AEROSTAR INTERNATIONAL, INC.

SERVICE LETTER 110

SUBJECT: Modifications to the Aerochute vent/deflation system in S-81A.

S-81A Aerochute Retrofit Instructions

DETAIL CT

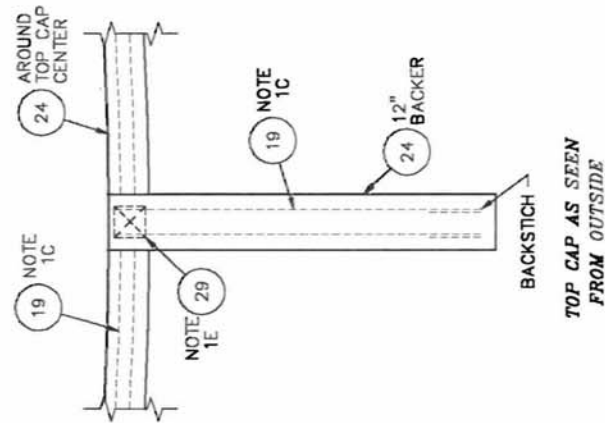
Top Cap: (Refer to Pages II & III) Install center tabs, center tab backers and 1" webbing around the perimeter of the top cap nucleus. (See drawing "DETAIL CT")

DETAIL KF

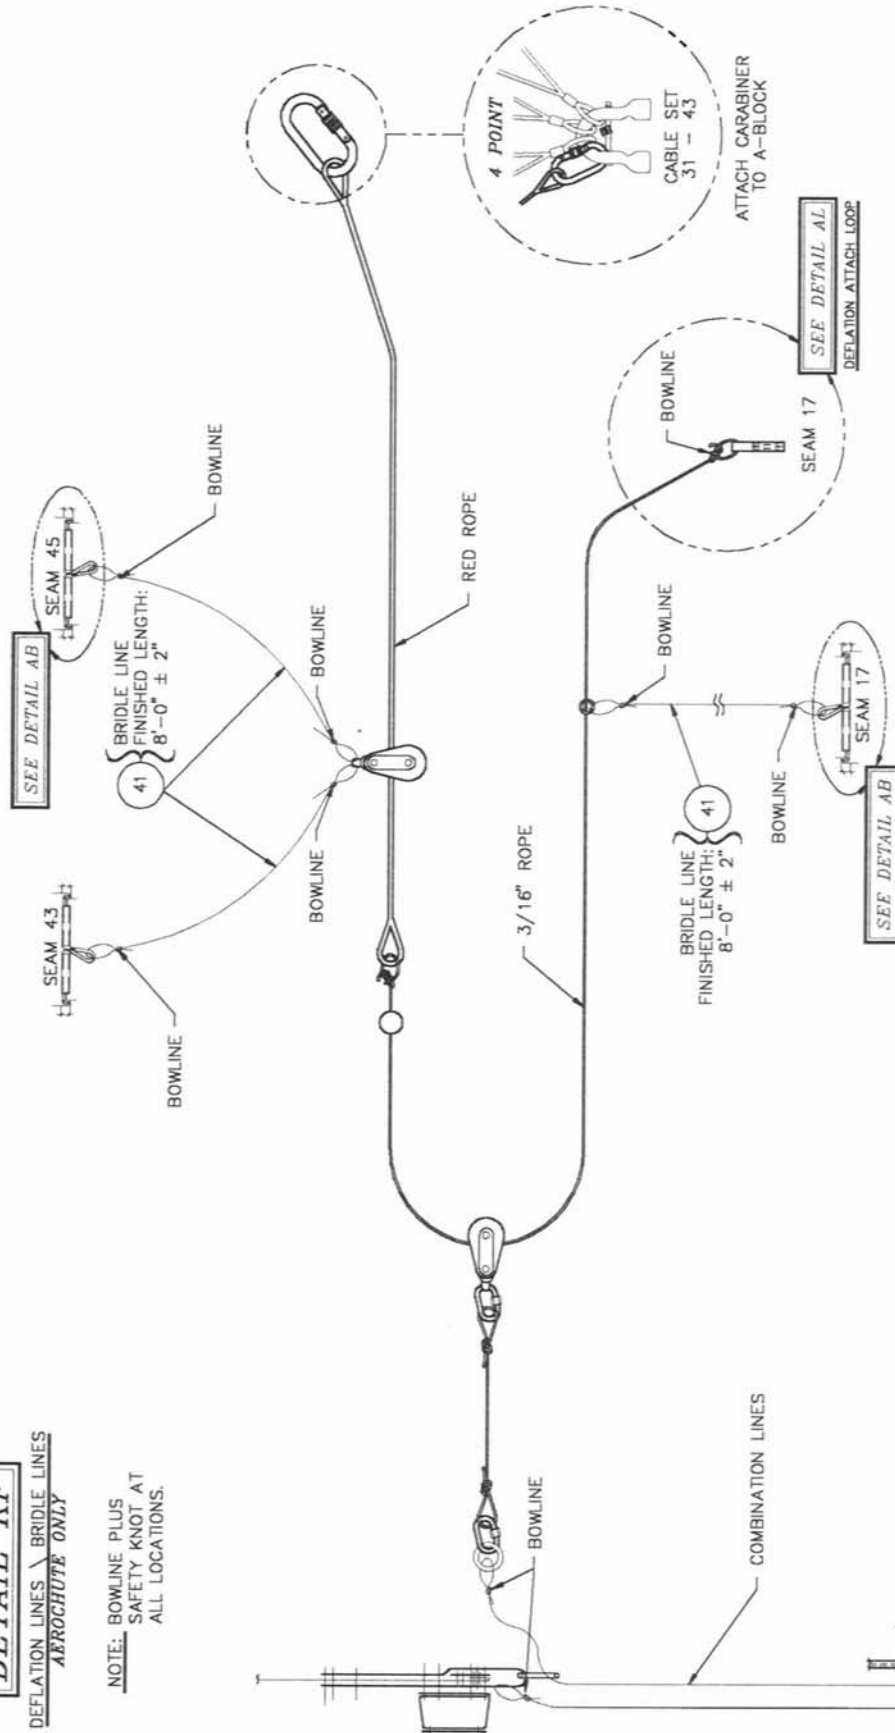
Aerochute Deflation - Vent Pull Assembly: (Refer to Page V, VII) Install deflation attach loop on "seam 17"; top of loop at "station 19", (See drawing "DETAIL AL" page VII). Install one bridle anchor on "seam 17, station 41" (See drawing, "DETAIL AB" page VII). Install single 8 foot bridle line with guide ring. Install 2 bridle anchor loops, "seams 43 and 45" at "station 49.0" (See drawing, "DETAIL AB" page VII). Install 8ft. Bridle cords and pulley.

Route vent pull line assembly as specified on Page V. (Note * Lines stay on the inside of all rotator lines.)

DETAIL KG
CENTER TOP CAP PULL
AEROCHUTE ONLY

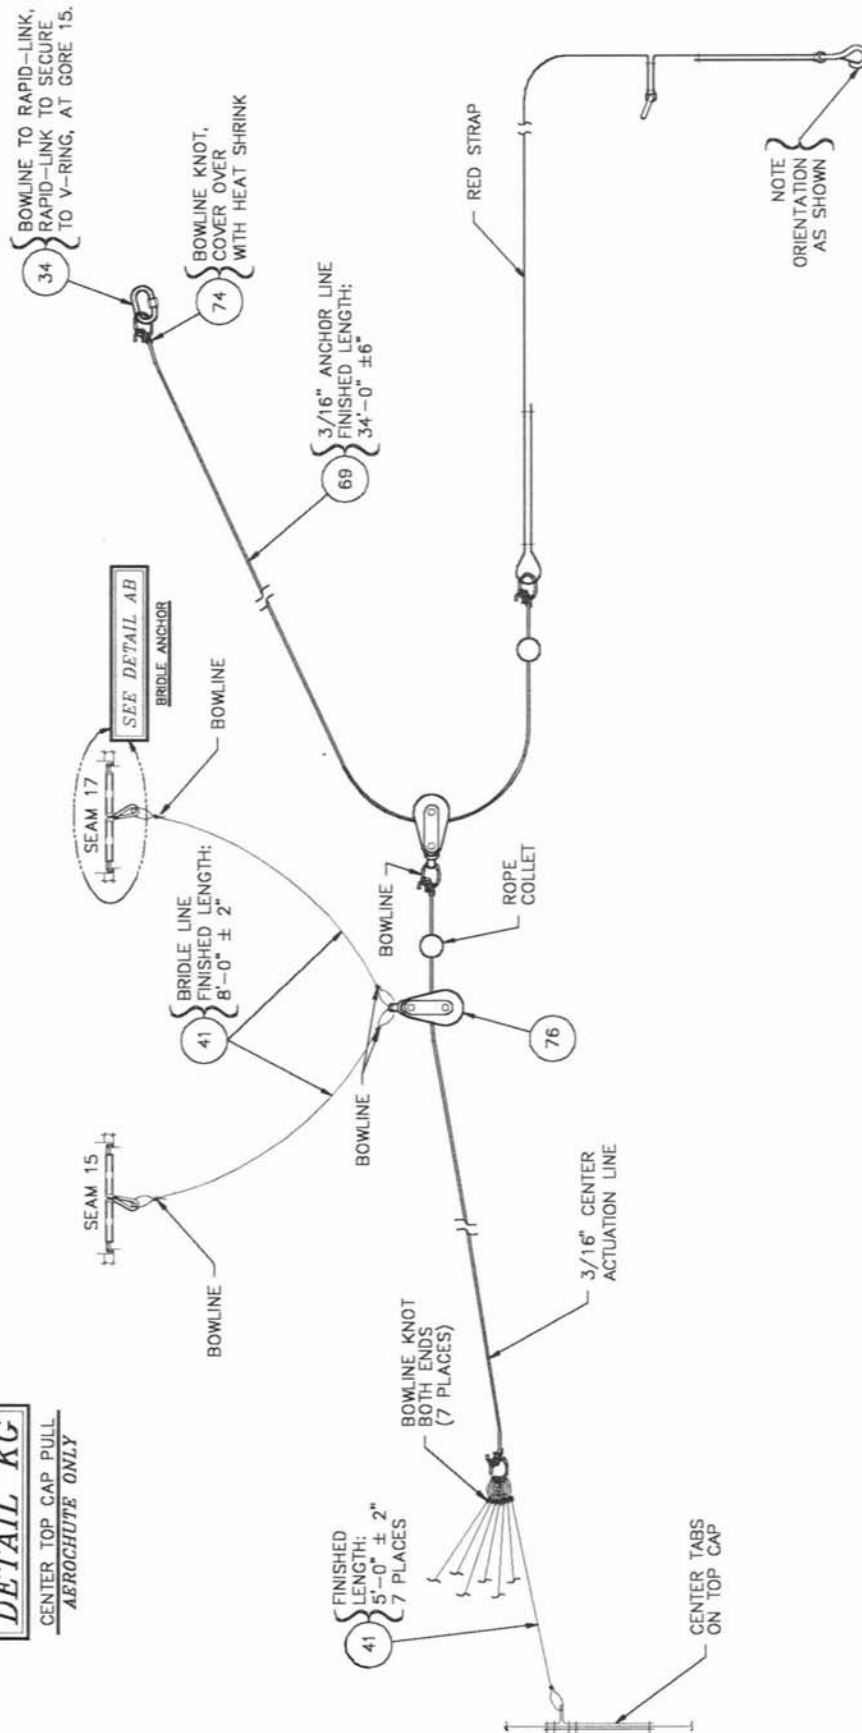
Aerochute Center Pull Assembly: (Refer to Page VI,VII) Install (7) center pull cords to top loop of center pull rope and to new center tab loops on inside of top cap.

Route top cap center pull line assembly (See drawing **“DETAIL KG”**, page VI).

DETAIL AB

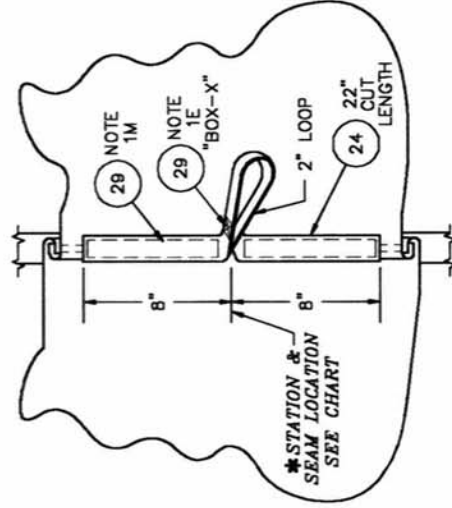
Install bridle anchor loops on “seams 15 and 17” at “station 49” (See drawing, **“DETAIL AB”** page VII).
